802.3dj D3.2

Comment Resolution

Common Topics

Matt Brown (Qualcomm), 802.3dj Chief Editor
Tom Huber (Nokia)
Leon Bruckman (Nvidia)

Figure 178B–10a—Training control state diagram, part 1

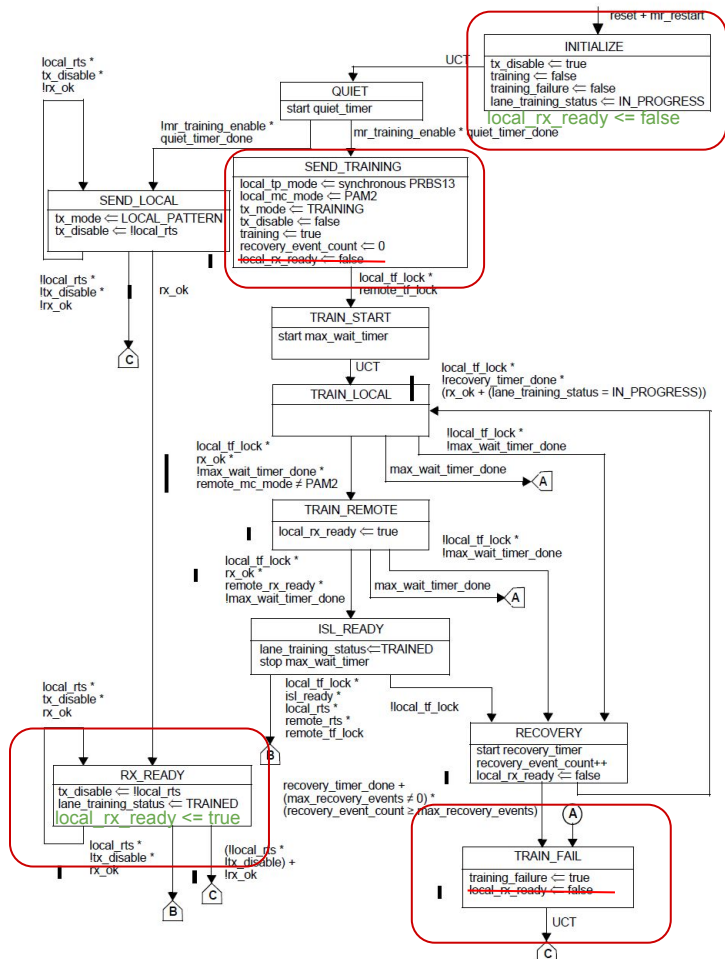
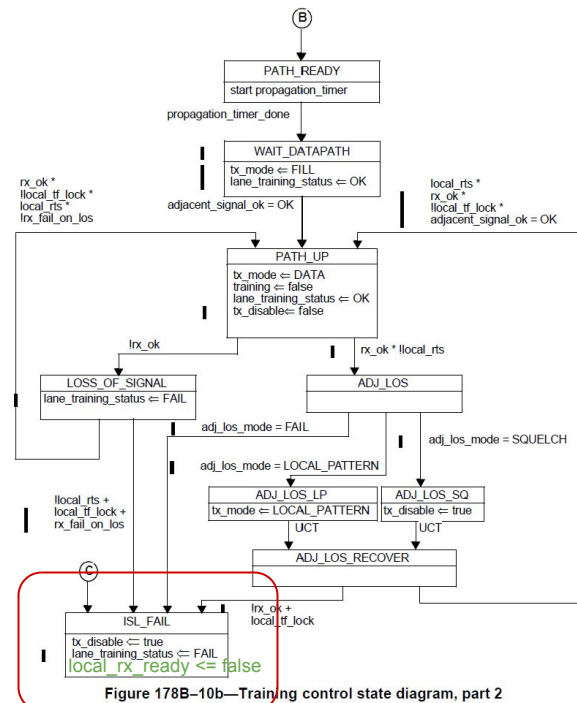
The D3.2 split of the D3.1 variable local_rx_ready into the new rx_ok (page 899, which took over the substantive "receiver is ready / no further adjustments required" definition and all the state-diagram conditions) plus a retained-but-redefined local_rx_ready leaves local_rx_ready inconsistent with its remaining consumers. Its definition is now reduced to "Boolean variable that indicates the state of the receiver. Its value is set by the training control state diagram (Figure 178B-10a).", which does not say which state of the receiver is indicated, nor the conditions for true and false. In Figure 178B-10a, local_rx_ready is set true only on entry to TRAIN_REMOTE and set false on entry to SEND_TRAINING, RX_READY (nearest numbered line, page 901 line 42) and TRAIN_FAIL - Figure 178B-10b never assigns it. It is therefore false throughout RX_READY, PATH_READY, WAIT_DATAPATH and PATH_UP, i.e. during normal data transmission. Three consumers were not updated and still cite local_rx_ready: isl_ready (178B.8.2.1, page 893, "set to true when local_rx_ready and remote_rx_ready are true for all lanes"), PMD_signal_detect_i (179.8.5, page 426 line 35, "the logical AND of the variables local_rx_ready and remote_rx_ready"), and register bit 1.1476.8 "isl_ready" (45.2.1.169c, page 102 lines 24 and 26). Since isl_ready is also a condition in the RTS update state diagram (Figure 178B-9, page 896 lines 10 and 22) and on the ISL_READY exit (page 901 line 38), as drafted isl_ready and PMD_signal_detect_i can never remain true in the operational states. Separately, the SEND_LOCAL branch of Figure 178B-10a (entered from QUIET on "!mr_training_enable * quiet_timer_done") never assigns local_rx_ready at all, leaving it undefined whenever mr_training_enable is false, although PMD_signal_detect_i and management bit 1.1420.15 read it with no mr_training_enable guard.

Resolve the split consistently. Either (a) do not clear local_rx_ready on entry to RX_READY (and TRAIN_FAIL and the PATH states as applicable) so that it stays true from TRAIN_REMOTE through PATH_UP, and give it a substantive definition on page 898 stating the conditions for true and false - or (b) if local_rx_ready is intended only as the transmitted "receiver ready" status bit of the training frame, restate the consumers in terms of rx_ok: change isl_ready in 178B.8.2.1 (page 893) to "set to true when rx_ok and remote_rx_ready are true for all lanes of the interface", change PMD_signal_detect_i in 179.8.5 (page 426 line 35) to "the logical AND of the variables rx_ok and remote_rx_ready", and update the 1.1476.8 descriptions in 45.2.1.169c (page 102 lines 24 and 26). In either case add "local_rx_ready <= false" to the action block of the SEND_LOCAL state in Figure 178B-10a (page 901 line 13) so the variable is defined on the non-training path.

ACCEPT IN PRINCIPLE.

Make the following changes to Figure 178B-10a/10b.

- In the SEND_TRAINING and TRAIN_FAIL states, delete "local_rx_ready <= false".
- In the INITIALIZE and ISL_FAIL states, add "local_rx_ready <= false".
- In the RX_READY state, add "local_rx_ready <= true".

Figure 186-3—800GBASE-ER1 FEC functional block diagram

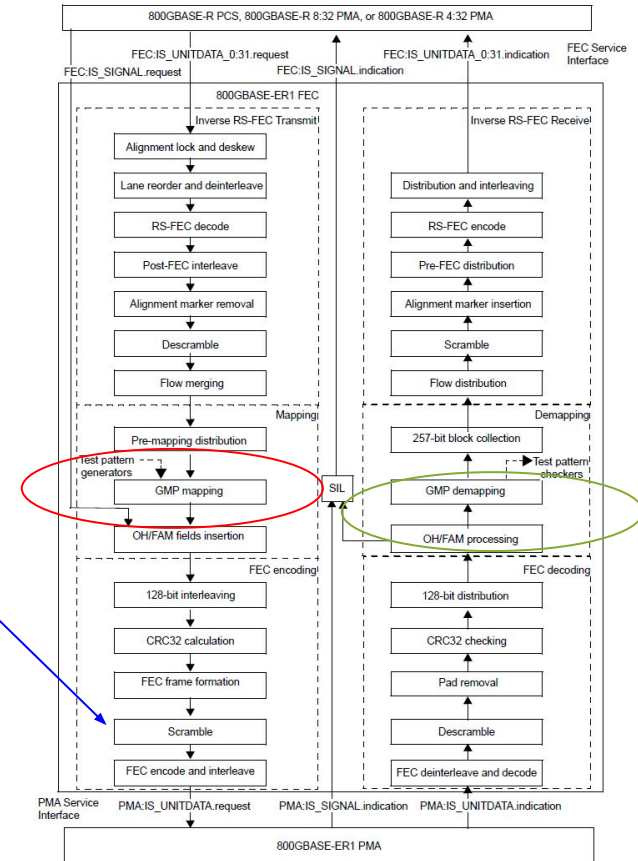
In the first row, the value is "FEC:IS_UNITDATA.request" but this is a name of a service interface primitive, which communicates the input from the client (PCS or PMA). It does not describe the payload, because the payload is the output of the "Pre-mapping distribution" block (based on Figure 186-3) which has gone through the "inverse RS-FEC transmit" processing.

In summary, the payload depending on FEC:IS_SIGNAL.request(SIGNAL_OK) is either the output of the "Pre-mapping distribution" block, or the encoded PRBS31 test pattern generator; this would match Figure 186-3. There is no "scrambled idle" or "LF" generator in the transmit direction.

The GMP mapper must always have data to map. This is not adequately described in the current text.

- In normal operation that is the signal coming from the AUI, as transformed by the processes prior to the GMP mapper (which is not FEC:IS_UNITDATA.request).
- During APSU, the signal from the AUI is not forwarded, so a replacement is needed.
 - In typical implementations of this type of interface, this is a test pattern or Idle signal
 - Exactly what it is doesn't really matter since it won't be forwarded and there is a scrambler before FEC encoding
- If the AUI is failed, LF should be inserted in the transmit function

Add to the end of 186.2.3.1.7:

"When IFEC_align_status is true, this stream is provided to the pre-mapping distribution function. Otherwise, a stream of 257-bit blocks containing local fault ordered sets is provided to the pre-mapping distribution function."

Replace first paragraph of 186.2.3.3:

"The input to the GMP mapper is either the stream of 257b blocks output from the pre-mapping distribution function or a locally generated signal such as the test pattern defined in 186.2.3.12."
